RE: Discharge of Condition 6 in regards to DM/23/3182.

AT: Burgess Hill Northern Arc, Land North And North West Of Burgess Hill, Between Bedelands Nature Reserve In The East And, Goddard's Green Waste Water Treatment Works In The West

REFERENCE: DM/25/0091

- Materials – Equipment (Dwg No. 162).

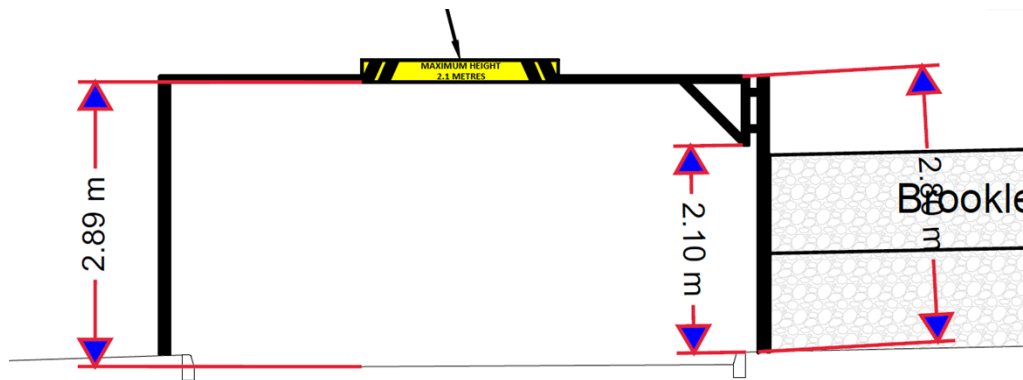
The plans show the typical internal unit, this appears to be domestic extractor fan, very little information has been provided regarding the air movement within the building, particularly with respect to ventilation in the toilets and shower rooms, which is essential to prevent issues with odours and moisture. The extraction rates should be designed in line with the rating of the rooms following the CIBSE Guidance. Do we have details of the designed system? A domestic extraction unit is not considered to be suitable for the intended use within a commercial building and as such it is not considered that this would be the typical unit.

Please refer [Designphase drawing Ventilation Drawing 811RevJ.pdf](#) prepared on behalf of the Contractor showing the ventilation layout including supply, extract, and heat recovery. The Contractor has advised the following in relation to design and the Approved Inspector will be required to sign-off Building Regulations compliance.

In relation to Burgess Hill I have consulted with our mechanical engineer, who has confirmed that the Ventilation System was based on a mechanical ventilation strategy in accordance with Building Regulation Part F2. Additionally, all equipment selected is suitable for a commercial environment.
